Visual-Manual NHTSA Driver Distraction Guidelines for In-Vehicle Electronic Devices; Notice

[Docket No. NHTSA–2010–0053]

Visual-Manual NHTSA Driver Distraction Guidelines for In-Vehicle Electronic Devices

ACTION: Notice of Federal guidelines.

Figure 2: Drawing of Slide Presented by Toyota at NHTSA Technical Workshop¹³⁶

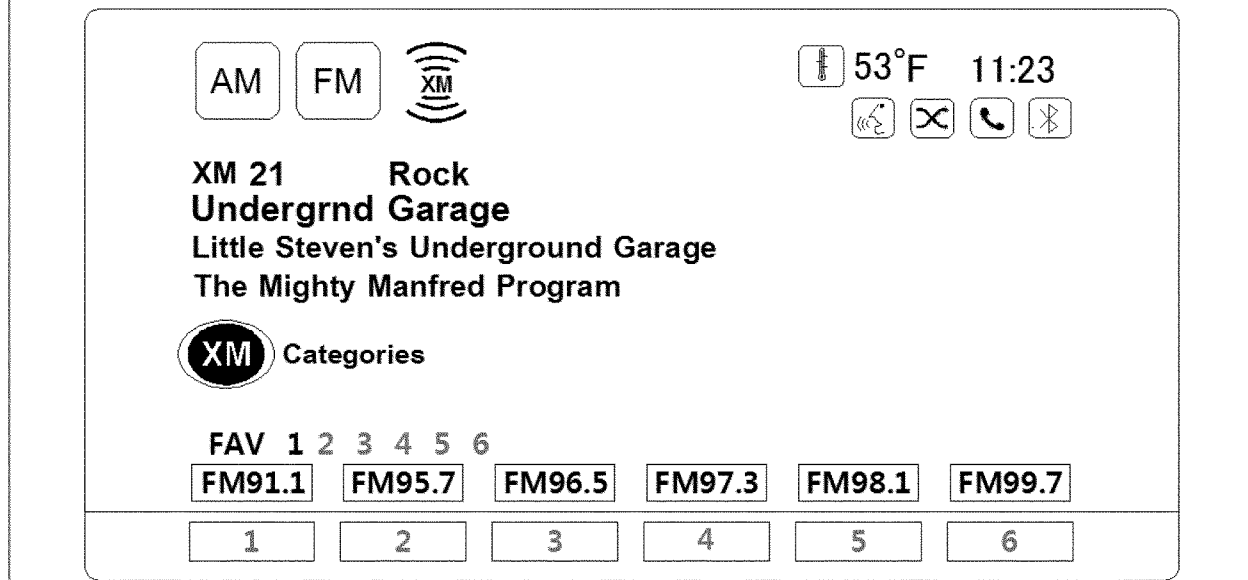
radio station program information (See Figure 2 below). He then asked:

five characters. So once we have the presets presented to the user, we can't give them any other information about what the radio is doing. If you pick any one element within this display, you quickly exceed a 30-character limit * * *¹³⁵

Where should the 30 character limit be applied to this display?

Mr. Foley then pointed out that the information conveyed by this display is easily grasped and that drivers do not have to read each individual letter to understand what is being transmitted by this display.
